Re: DRC 1st Round Review Comments for proposed Sherlock Storage Facility (SPR17-001 and CUP17-001) – Request for Corrections/Additional Information

To:	David & Aaron Beal	Date:	April 6, 2017
Project Number / Name:	SPR17-001 / CUP17-001 Sherlock Storage Facility		
Review Number:	1 st Round Review Comments		
Project Description and Location:	Proposed self-storage facility at 14441 Main Street NE

RE: Sherlock Self-Storage - Sensitive Areas Compliance Review

Figure 1. Duvall Village Off-site Enhancement Areas (with further indication of other previous restoration / mitigation efforts along lower Thayer Creek) (WRI, 2016).

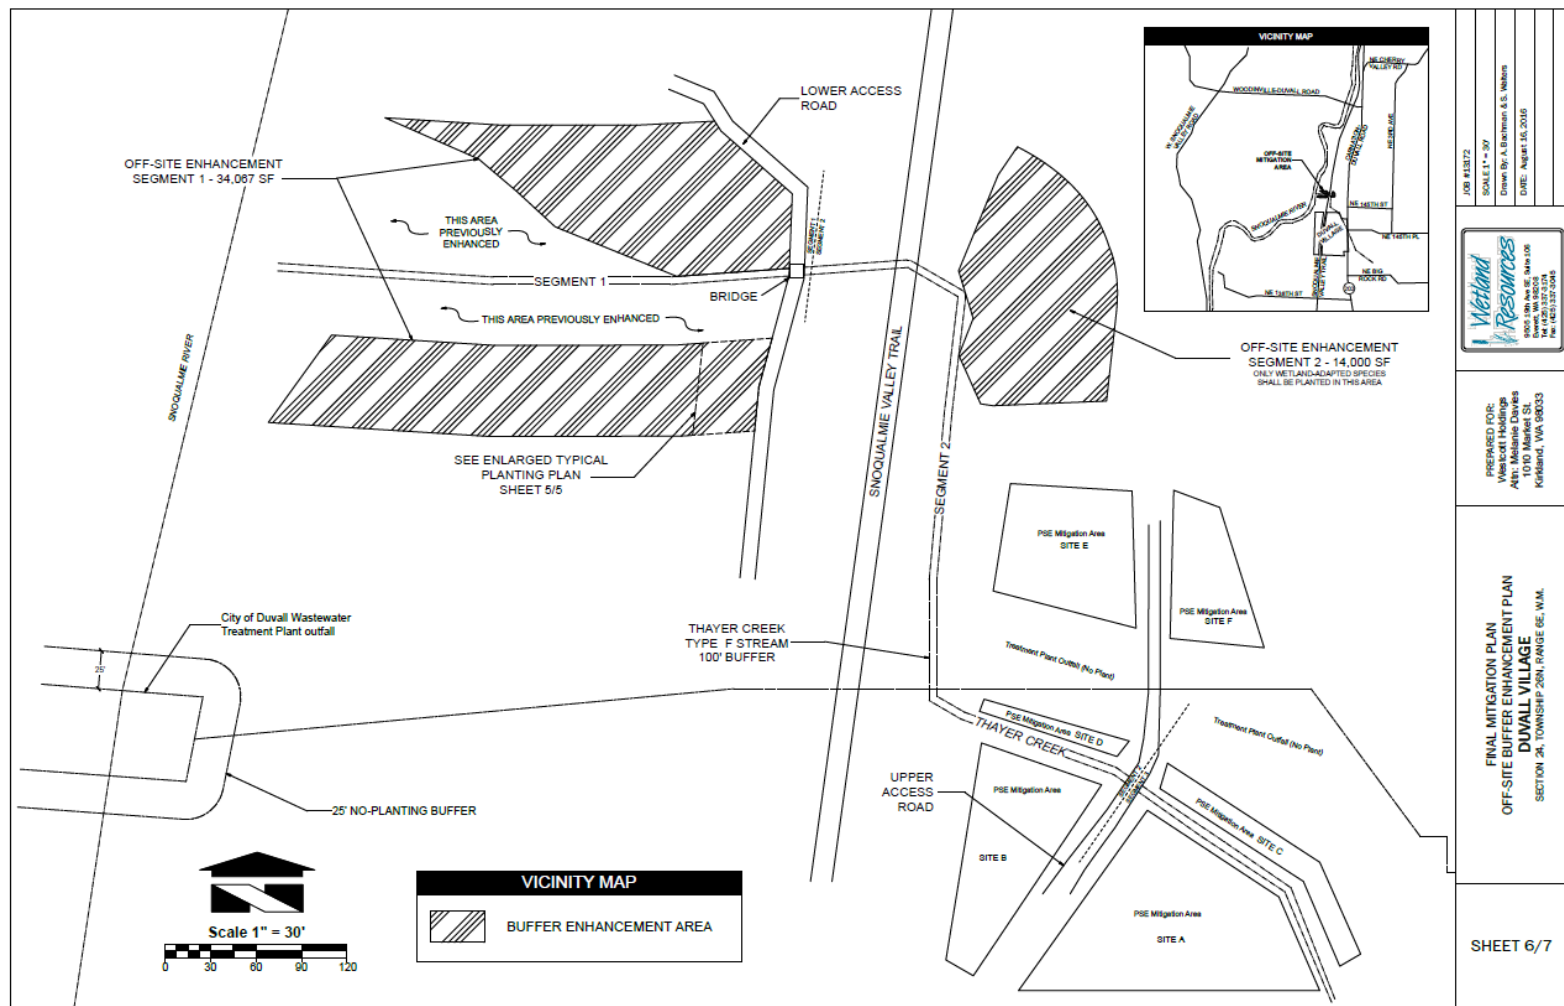
For proposed off-site enhancement of Thayer Creek downstream of the property, the applicant should ensure efforts are coordinated to eliminate overlap with other Thayer Creek enhancement efforts that have already been complete or are already underway. Specifically, the applicant should review the planting areas for the Puget Sound Energy Restoration project to the east of the Snoqualmie Valley Trail, and the Duvall Village off-site mitigation area. The restoration extents associated with these efforts are shown in the figure on the following page.

It appears that an ideal area for downstream enhancement could be the Thayer Creek corridor directly downstream of the subject property (and immediately west of the City's Wastewater Treatment Plan). Areas to the north of the subject property and Duvall Village property line, as well as areas to the south of the Puget Sound Energy (PSE) Restoration project enhancement area, could be sufficient to meet off-site enhancement requirements.
